## 2095 Dilworth Road, Kars, ON

### Servicing Options and Conceptual Stormwater Management Report

**Reference: 2095 Dilworth Road  
Response to City Technical Review Comments  
City File No.: D02-02-24-0029  
Novatech File No.: 123081**

DATE SEPT 2026 JOB 1253081 FIGURE SWM - PRE

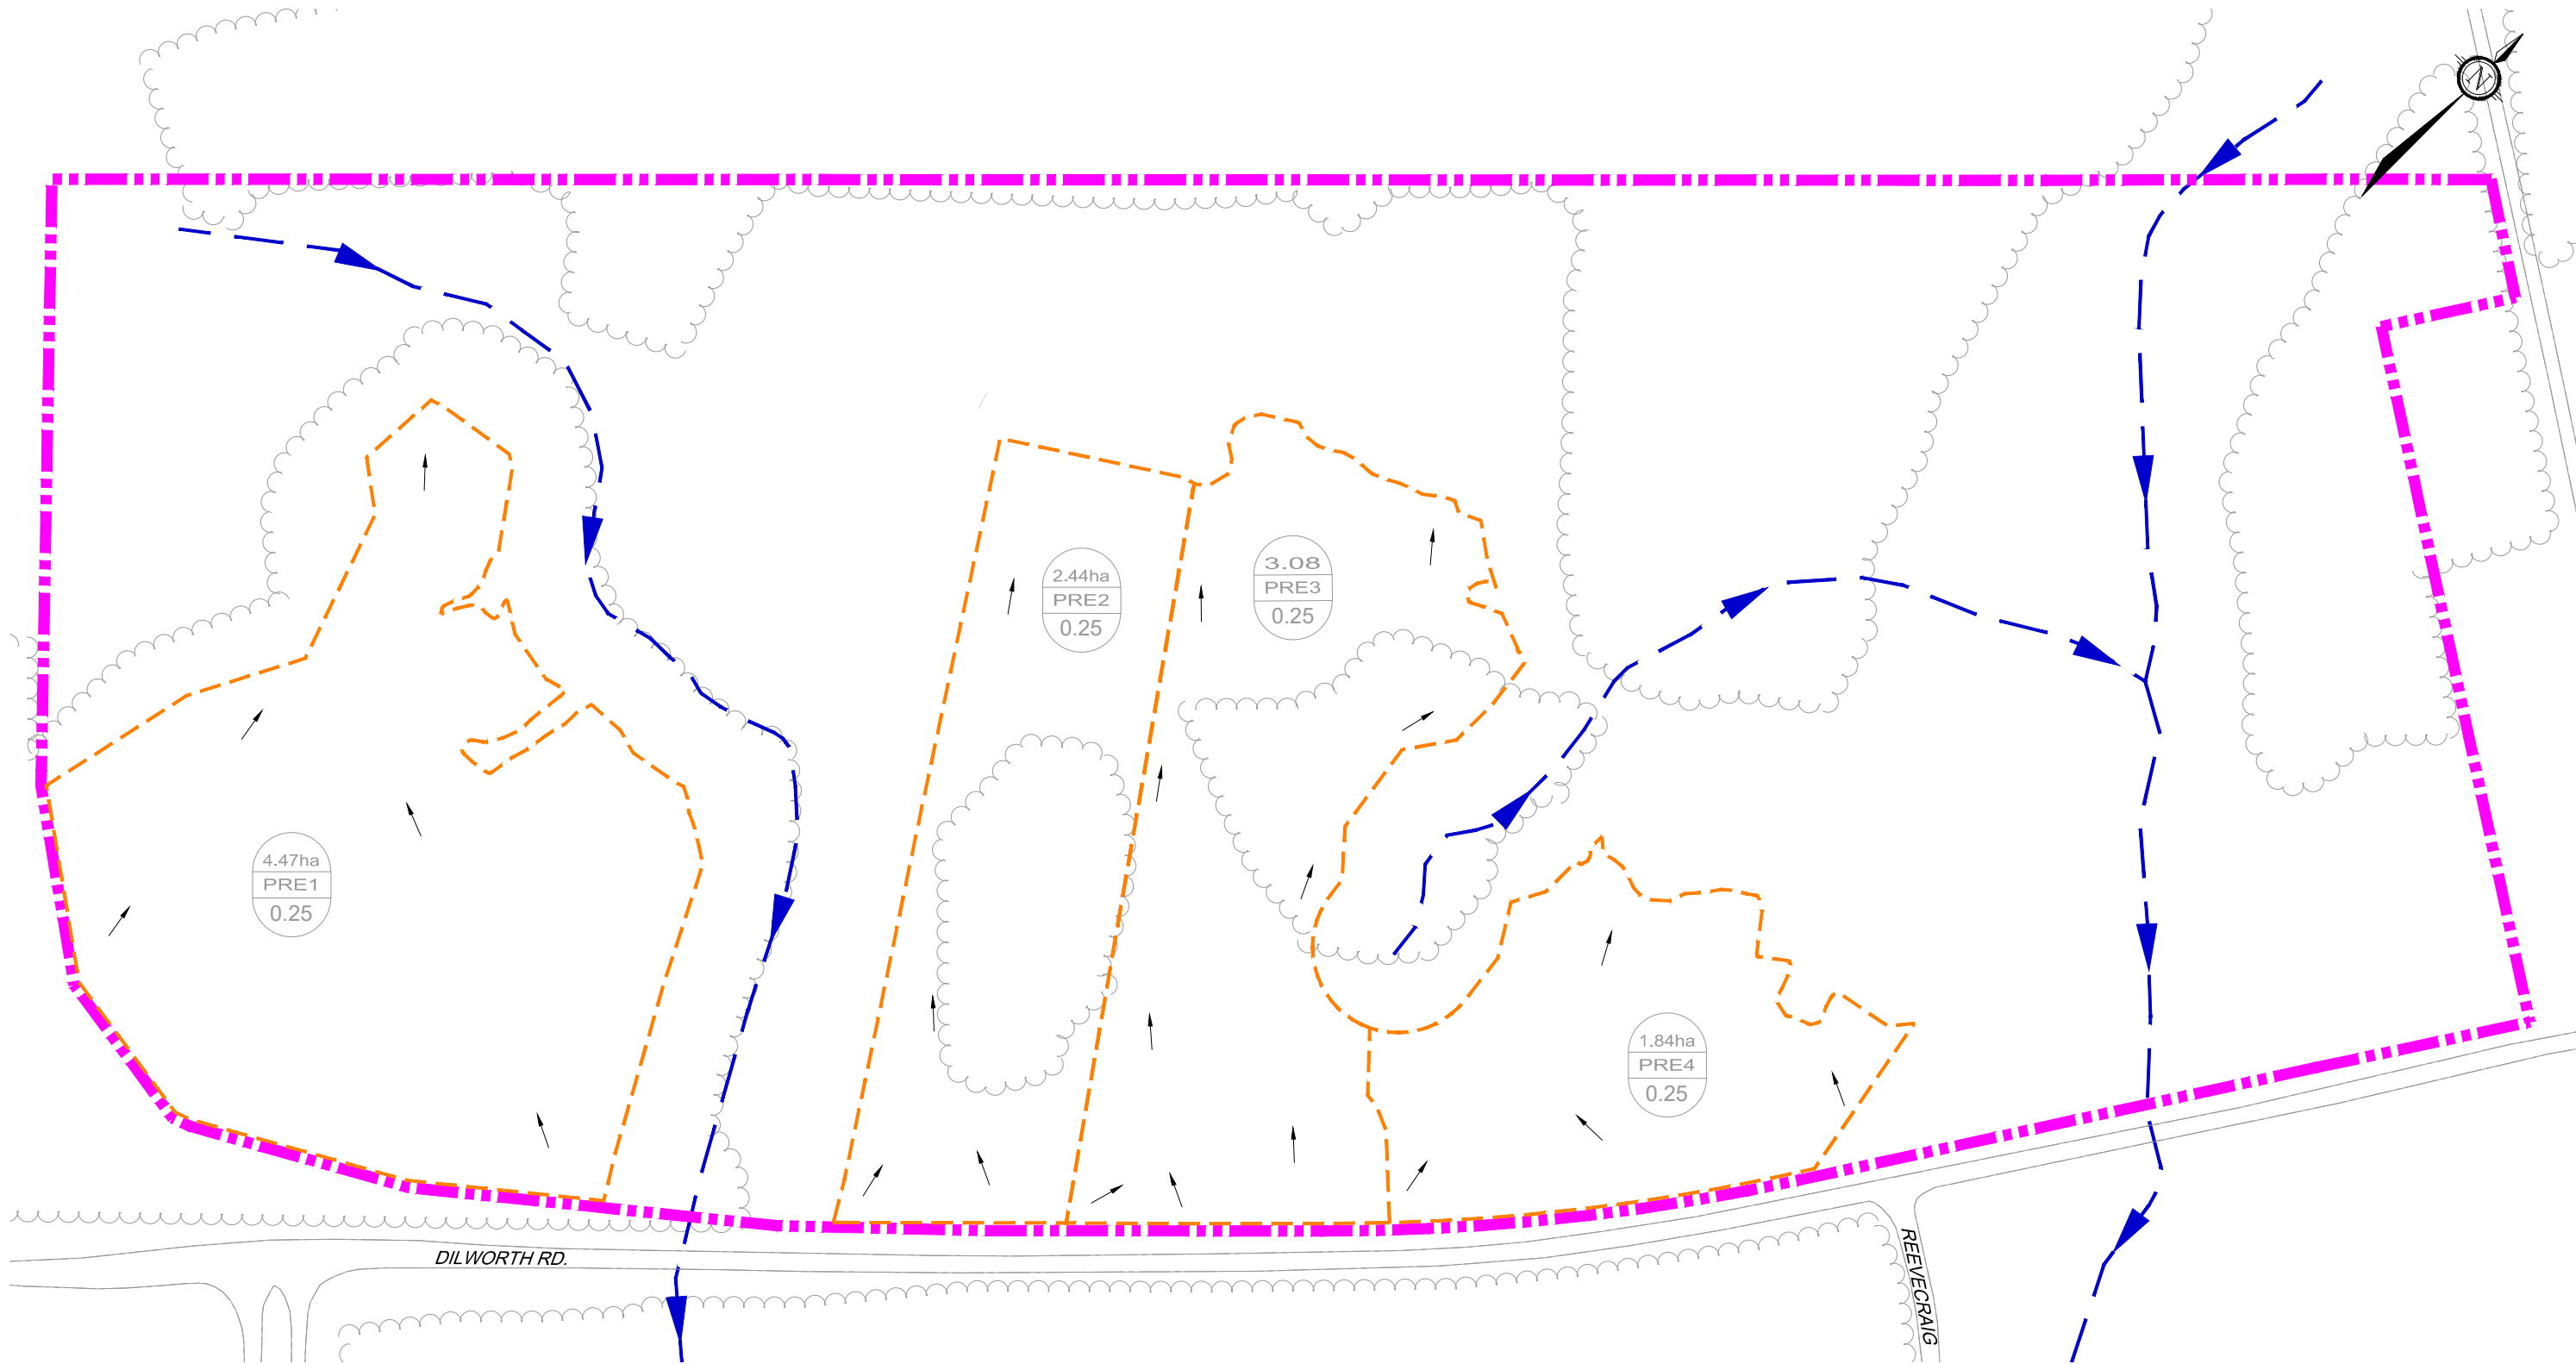
The previously-provided drainage pattern was removed from Figure 3; however, the matter of drainage pattern is still not clear. The drainage pattern arrows shown in Appendix SWM-PRE plan indicate that the MTO property is likely draining, across the property line, to the area PRE-1 (via northwest corner?).

DATE AUG 2026 JOB 123081 FIGURE DSK-1

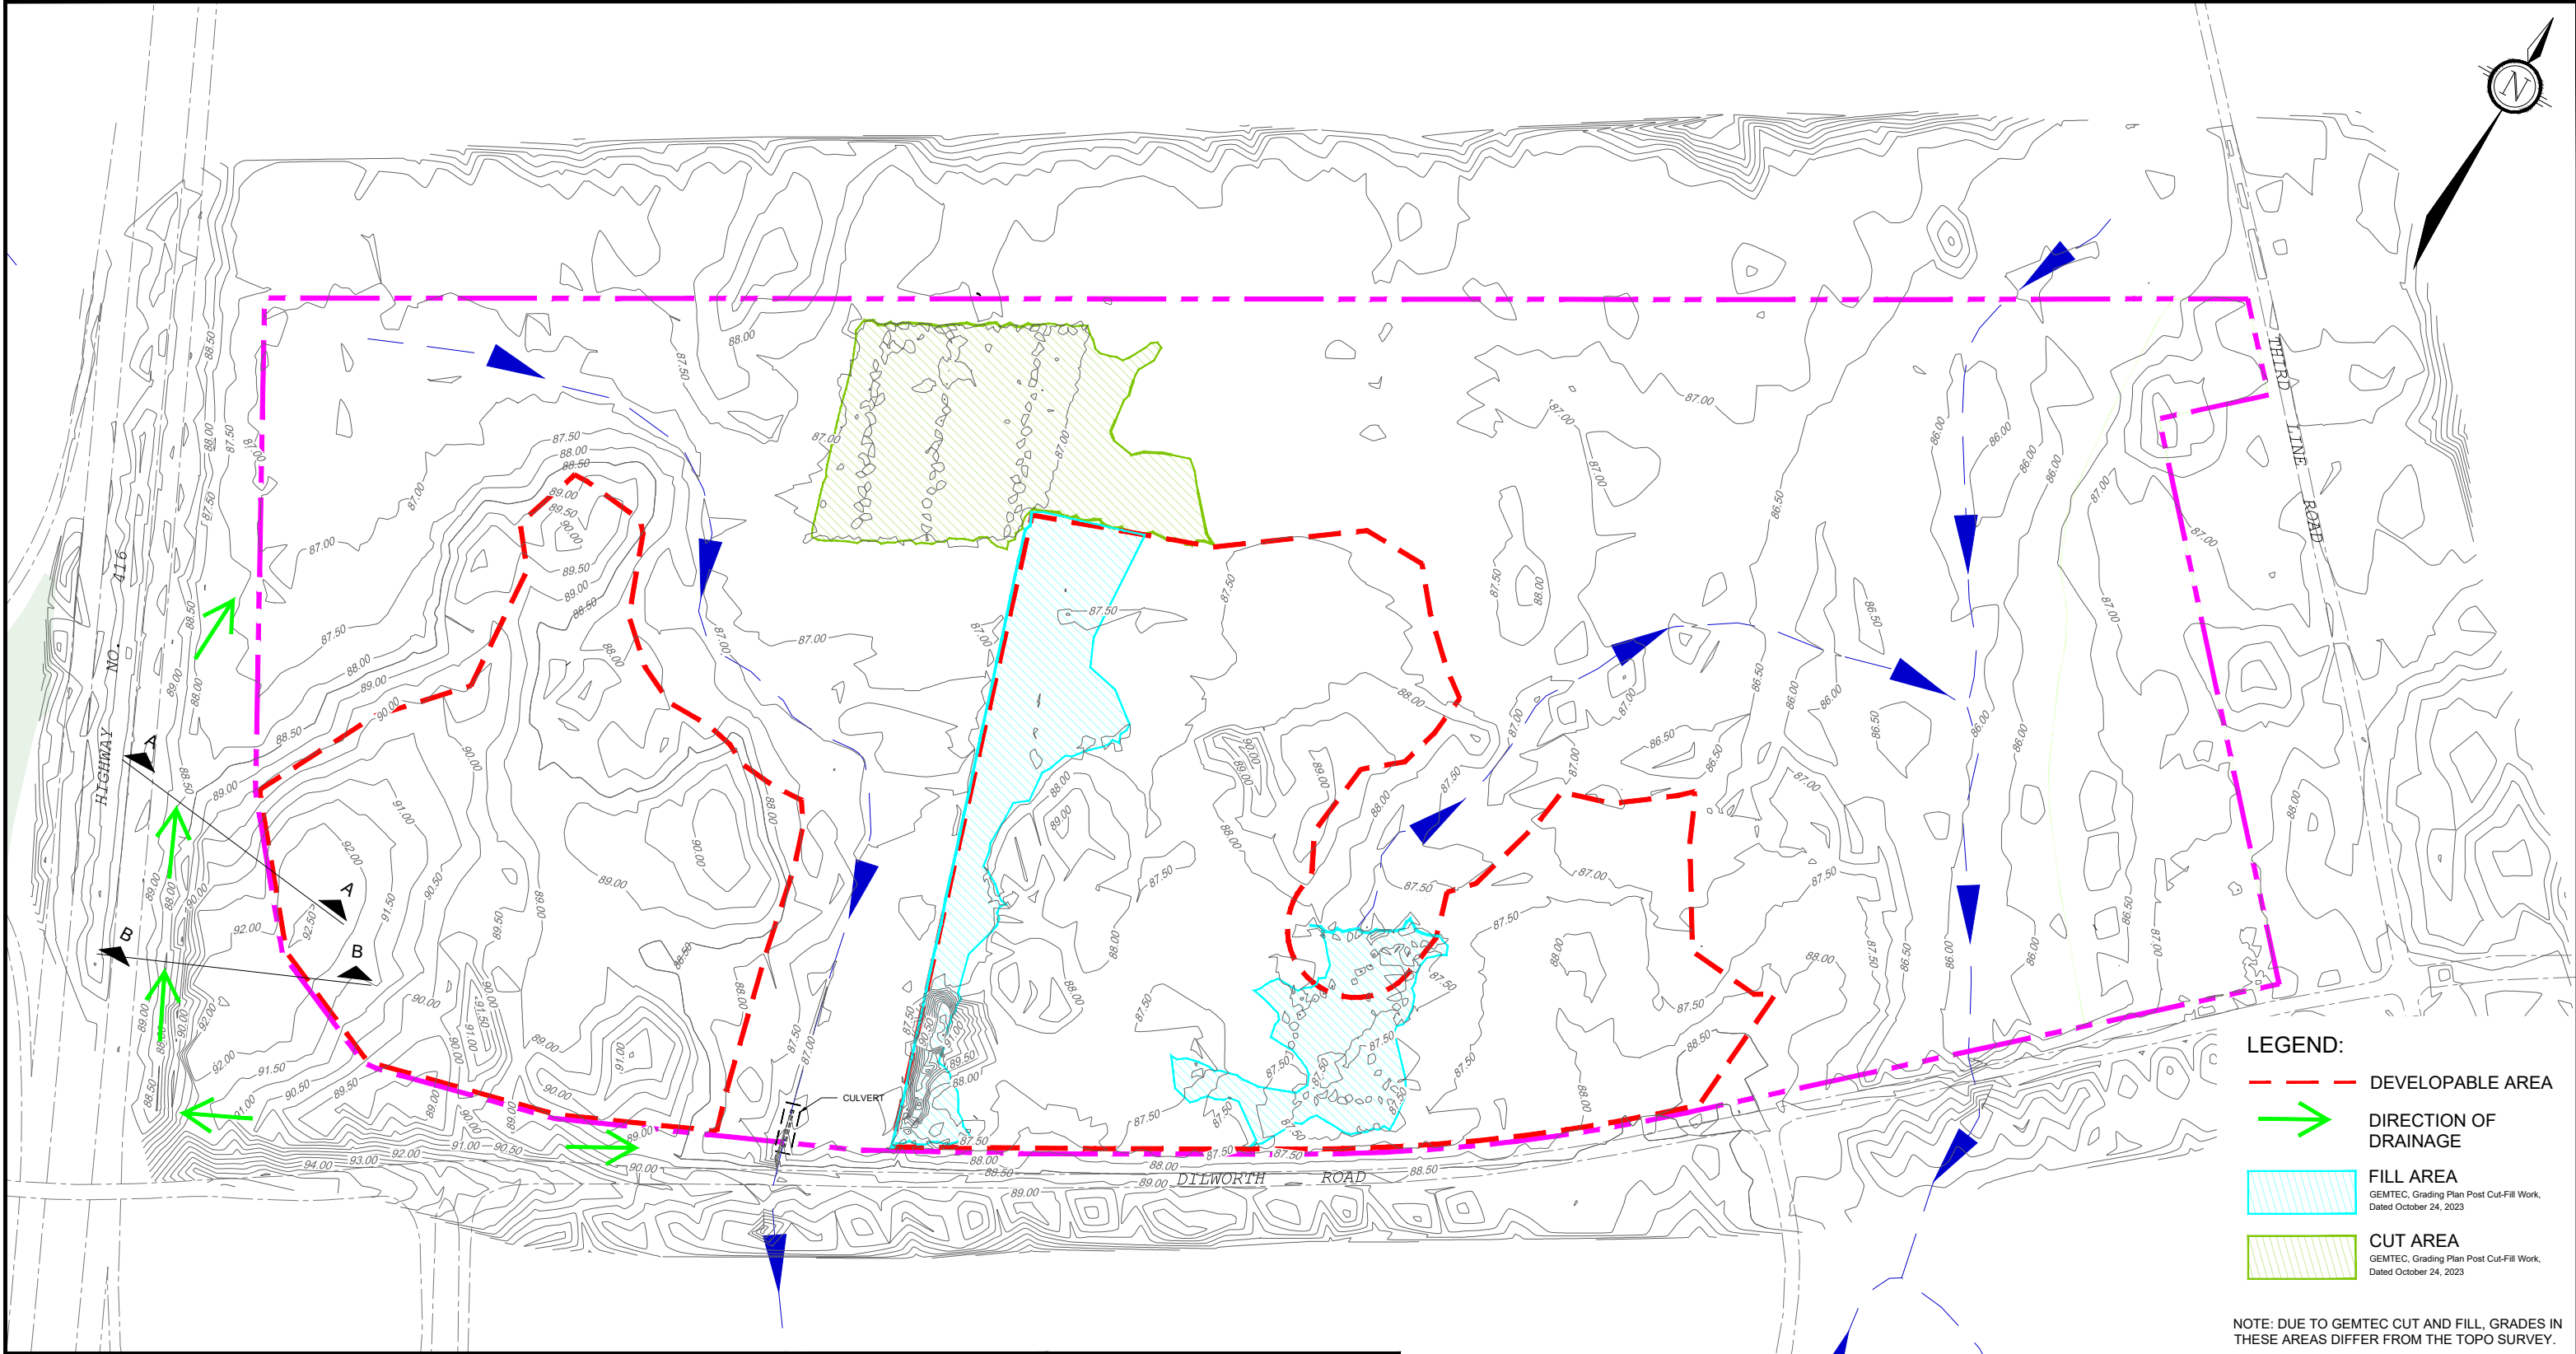
9. Aerial imagery from 2019 shows potentially existing drainage path from Highway 416 right-of-way, through the site, towards the on-site watercourse site. Change in the existing condition though potential development of the area designated as Area 1 may have an impact on the Highway 416 drainage.

The email correspondence with the MTO is noted; however, maintaining stormflows from the adjacent properties including from MTO's Highway 416 lands, among others, should be analyzed and specifically discussed in the report. The Pre/Post Development Drainage Areas Plan, included in Appendix B, does not appear to include any potentially existing off-site tributary flows, which need to be accounted for. **This comment was not addressed in the report.**

Please account for offsite flows and show the directions of surface runoff on the properties directly adjacent, which might contribute to SWM (Ponds A and D) on the site under consideration. Some flows might also be entering area PRE-4 across the property line. The report needs to be clear in establishing if external flows are applicable or not.

4. Regarding the potential offsite flows towards the future development areas, comment, previously related to Figure 3, the Novatech response mentioned that offsite flow directions were shown on a DSK-1 Plan. The mentioned plan was not included in the last submission. Please provide the DSK-1 Plan in the report. **Novatech Response: The figure will be included in report appendices with a copy of the response letter.**

*Novatech Response: It is our opinion that the highway drainage drains along a roadside ditch towards the wetland area and around the subject site. Please refer to attached figure DSK-1 that shows contour mapping. We have added drainage direction arrows to show the flow path of the highway drainage. We have also shown two cross sections which shows a low point between the highway and the site forming a drainage ditch. The highway drainage does enter the wetland area and follows the tributary and therefore, should be included in the drainage area for the culvert crossing Dilworth Road (as included in Gemtec's culvert calculations). The drainage does not affect the developable area of the subject site. Further review will be done through later Site Plan Application that will be required to lift the Holding Zone.*

*Novatech Response: Direction of drainage arrows for adjacent property have been added to the attached DSK-1 which shows that drainage from the adjacent property drains towards the tributary and not ponds A and D.*
